Arizona Department of Transportation

MEMORANDUM

Subject: C-Standards Update

Construction Standard Drawings Revisions – April 2006

APPROVED FOR DESIGN <i>May Vipawina</i>	STATE OF ARIZONA DEPARTMENT OF TRANSPORTATION ROADWAY STANDARD DRAWINGS	REV. 4/06
APPROVED FOR DISTRIBUTION <i>John Smith</i>	SLOPES RURAL UNDIVIDED AND FRINGE-URBAN HIGHWAYS	DRAWING NO. C-02.20

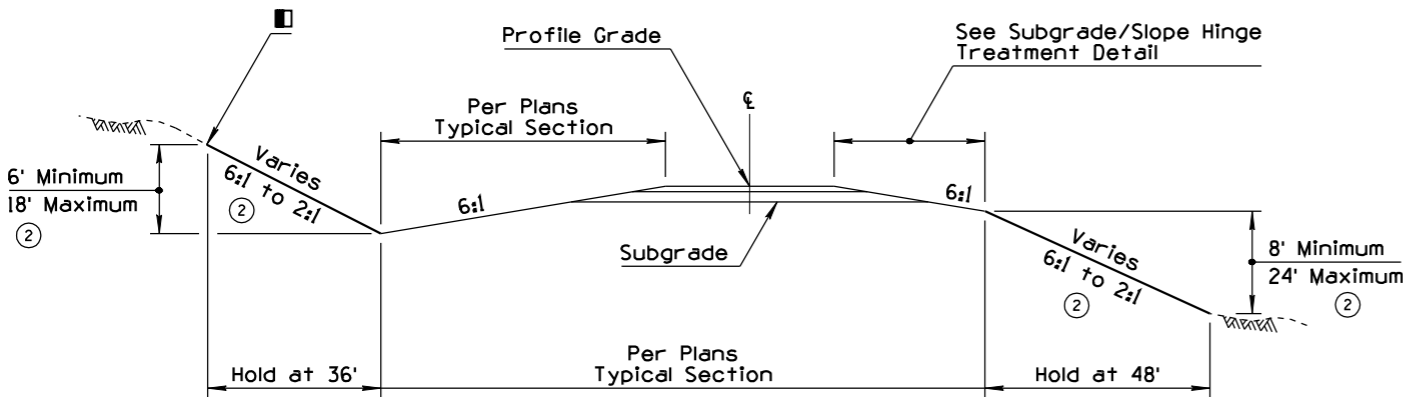
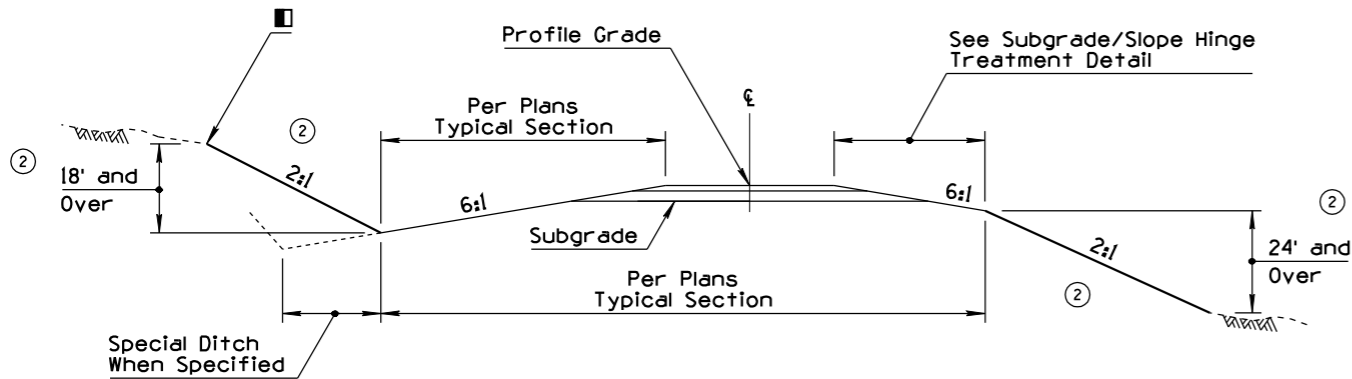
- C-02.20 & C-02.30: Revised cut and fill slope dimensions;
- C-05.30, Shts 3 & 4 of 7: Modified PLAN and PERSPECTIVE views to clarify ramp location;
- C-05.30, Sht 7 of 7: Added a PLAN and SECTION views for a brick detectable warning strip;
- C-10.76: Modified SECTION views to depict "F" shape; and
- C-11.10: Re-issued the drawings in four sheets. Sheet 4 shows the clamp designed to enhance the bicycle ridability of the cattle guard.

Please refer to the updated Construction Standard Drawings (Rev.date 4/06) that were issued today under separate e-mail notification. The maximum fill slope rates for Std. C-02.20 Rural Undivided and Fringe-Urban Highways and Std. C-02.30 Miscellaneous Roadways have been revised from 1 1/2:1 to 2:1. Also, the maximum cut slope rates for these two standards have been revised from 1:1 to 2:1. No slope changes have been made to Std. C-02.10 Rural Divided Highways. These revisions have been coordinated with the Materials Group Geotechnical Design.

The revisions to the slopes reflect what has been the norm for most projects. The 2:1 fill slopes provide a more stable embankment and provide an improved slope rate to establish vegetation and erosion control. The flatter 2:1 cut slope rates will also provide the same advantages. When in rock cuts, Geotechnical Design will continue to provide the maximum slope that can be used by the designer. Also, when cuts are in the higher ranges and there may be a significant project cost involved, Geotechnical Design will provide the designer the maximum slope that can be used to reduce the excavation required. The design process for establishing slope design for a project has not changed. The standard slopes simply provide the initial design slopes and the designer is to adjust the slopes for the project needs considering safety, material type, project costs, slope stabilization and other needs.

APPROVED FOR DESIGN <i>May Vipawina</i>	STATE OF ARIZONA DEPARTMENT OF TRANSPORTATION ROADWAY STANDARD DRAWINGS	REV. 4/06
APPROVED FOR DISTRIBUTION <i>John Smith</i>	SIDEWALK RAMP TYPE D	DRAWING NO. ① C-05.30 Sheet 4 of 7

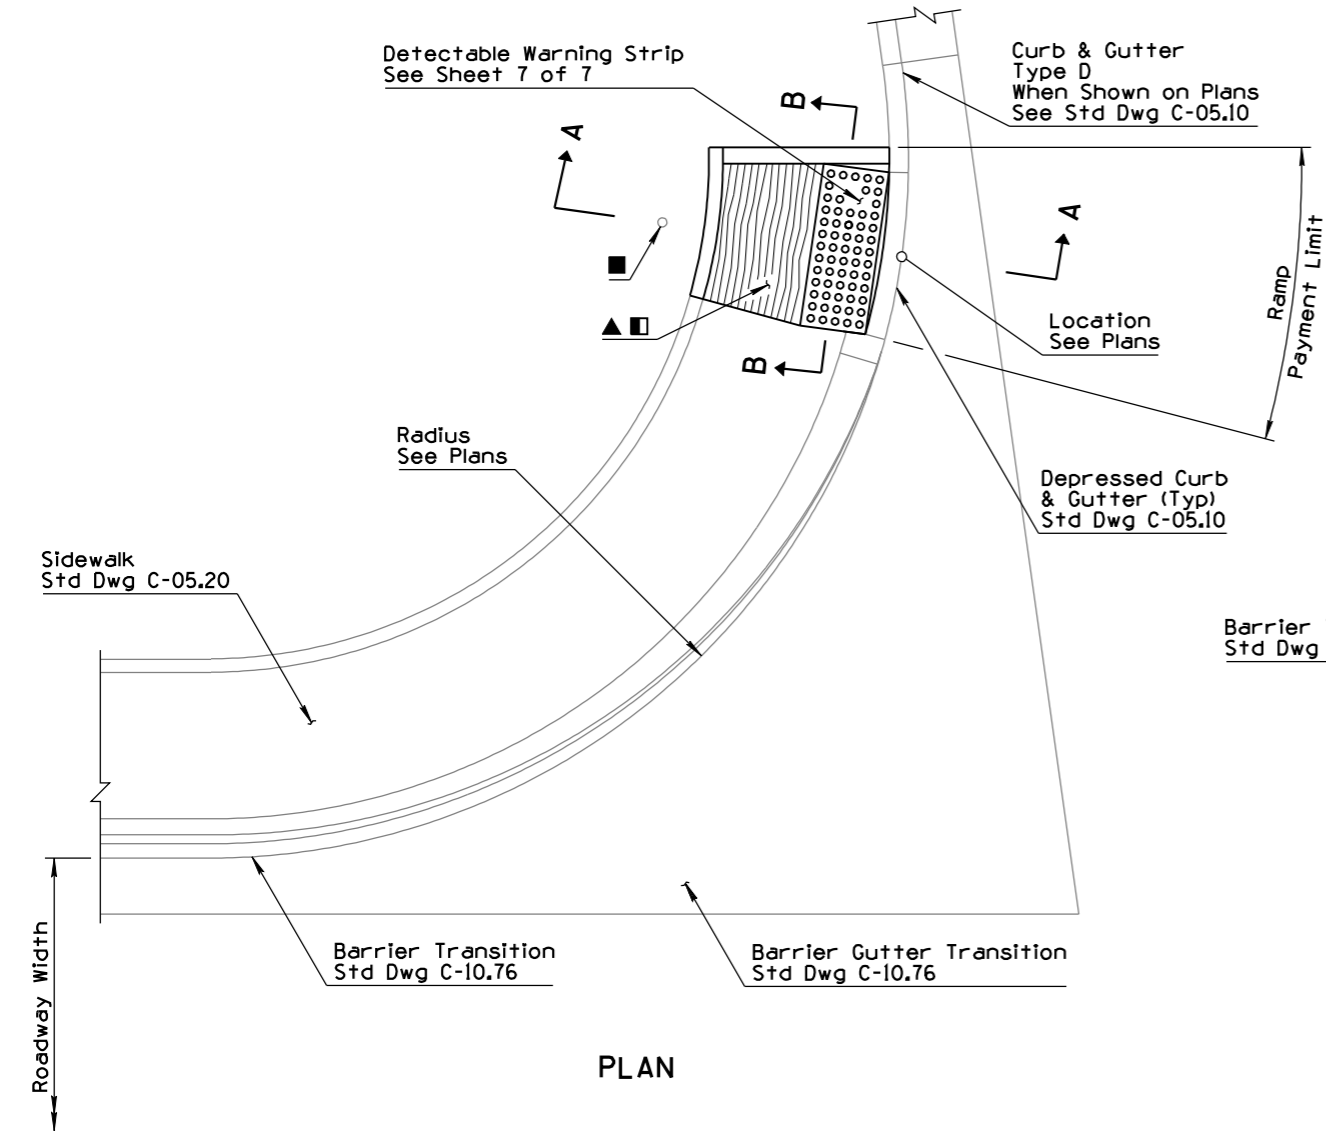
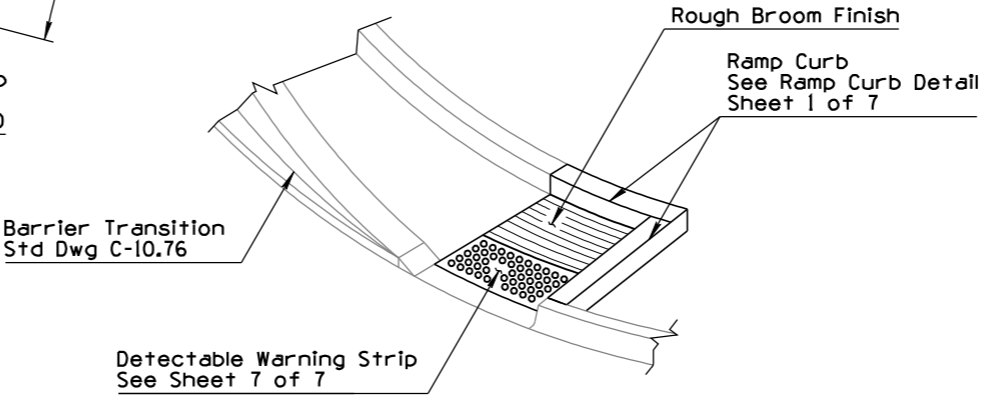
C-05.30, Sheet 4 of 7	Modified ramp location in PLAN and PERSPECTIVE views.
C-05.30, Sheet 5 of 7	Modified General Note 3.
C-05.30, Sheet 7 of 7	Added PLAN and SECTION views of brick option Detectable Warning Strip (DWS). Modified PLAN view of non-brick DWS. Added General Note 1. Re-labeled section and detail views.
C-05.50	Revised General Note 6. Rearranged drawings on sheet. Modified SECTION A--A. Revised Std Dwg reference in SECTION C--C. Re-labeled "PLAN VIEW OF SECTION C--C".
C-07.02	Revised General Notes 3 & 4 to correct Std Dwg reference from C-07.05 to C-07.04. Revised drawing titles.
C-10.51	Changed "PLAN VIEW" to "PLAN". Removed slope designation from sidewalk in SECTION views. Changed length of vertical taper from 12½" to 1'-0". Revised text orientation. Added "WITHOUT GUARDRAIL" to title of ELEVATION view of departure vertical taper.
C-10.52	Removed "D" reference and substituted "may" for "can" in General Note 5.

APPROVED FOR DESIGN <i>May Vipawina</i>	STATE OF ARIZONA DEPARTMENT OF TRANSPORTATION ROADWAY STANDARD DRAWINGS	REV. 4/06
APPROVED FOR DISTRIBUTION <i>John [Signature]</i>	CONCRETE HALF-BARRIER TRANSITION TYPE 'F' TANGENT DEPARTURE TYPE 1	DRAWING NO. C-10.75 Sheet 1 of 2

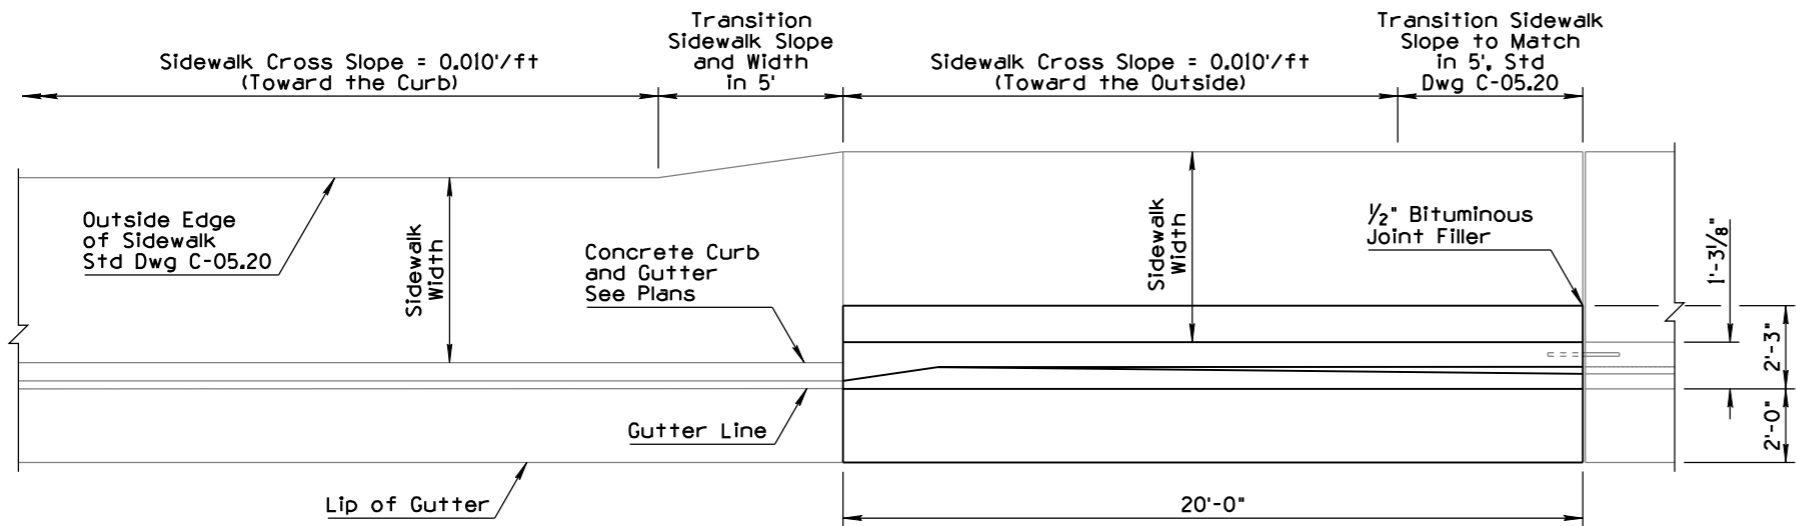
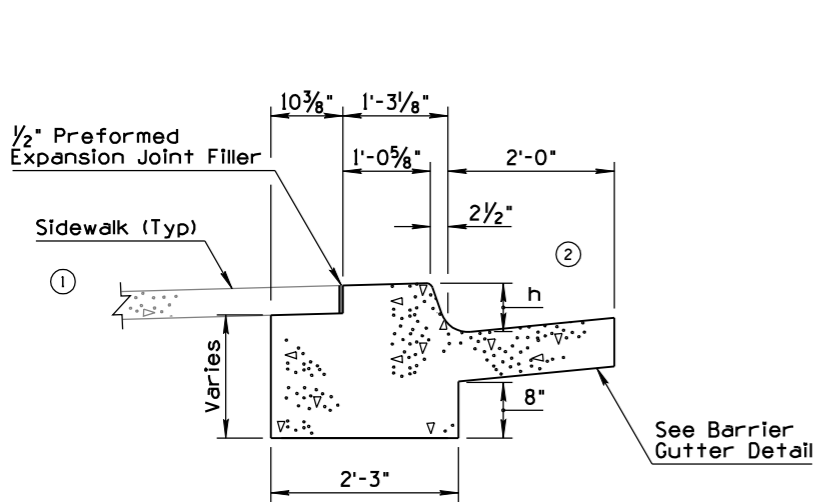
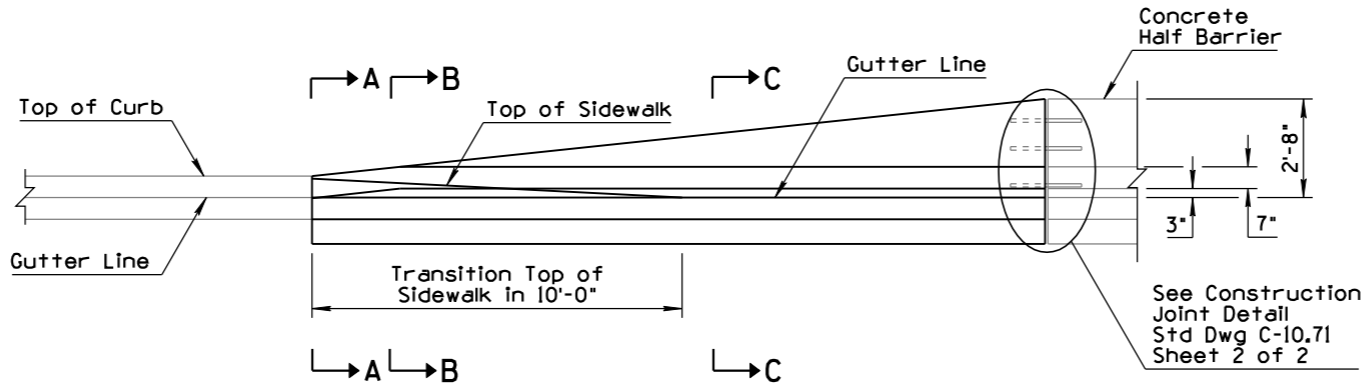
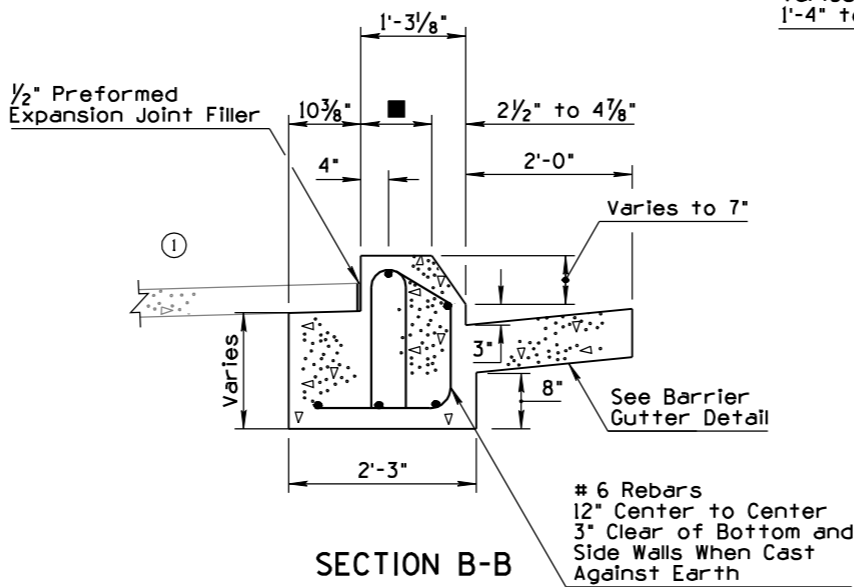
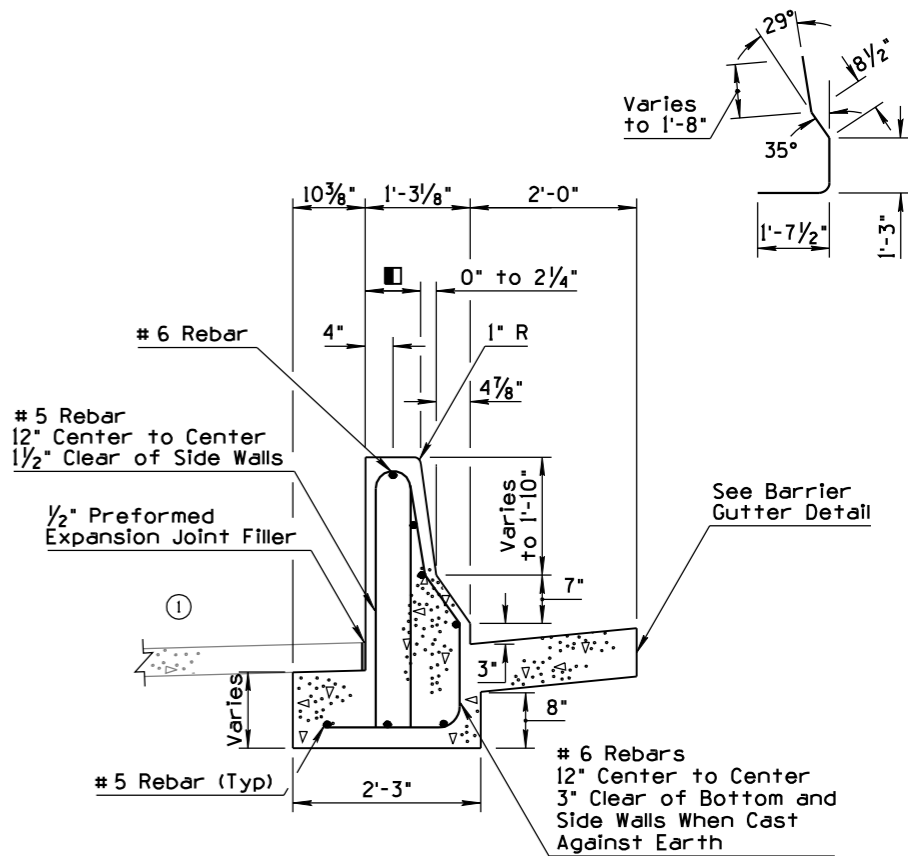
C-10.75, Sheet 1 of 2	Changed "PLAN VIEW" to "PLAN". Removed slope designation from sidewalk in SECTION views. Revised curb-height designation in SECTION A-A from "H" to "h".
C-10.75, Sheet 2 of 2	Changed "PLAN VIEW" to "PLAN". Removed dimensions at right side of PLAN view. Revised text orientation.
C-10.76	Changed "PLAN VIEW" to "PLAN". Revised SECTION view graphics to depict Type 'F' barrier.
C-10.77	Modified PLAN view to correct style and proportion of concrete half barrier and transitions. Modified references to other Std Dwgs.
C-11.10 Sheets 1 through 4 of 4	Re-issued Standard Drawing.
C-15.20, Sheet 1 of 3	Revised sheet number references.
C-15.91 & C-15.92, Sheet 2 of 2	Modified welding notations for ANSI conformance.
C-18.10, Sheet 2 of 3	Modified SECTION views to improve clarity.
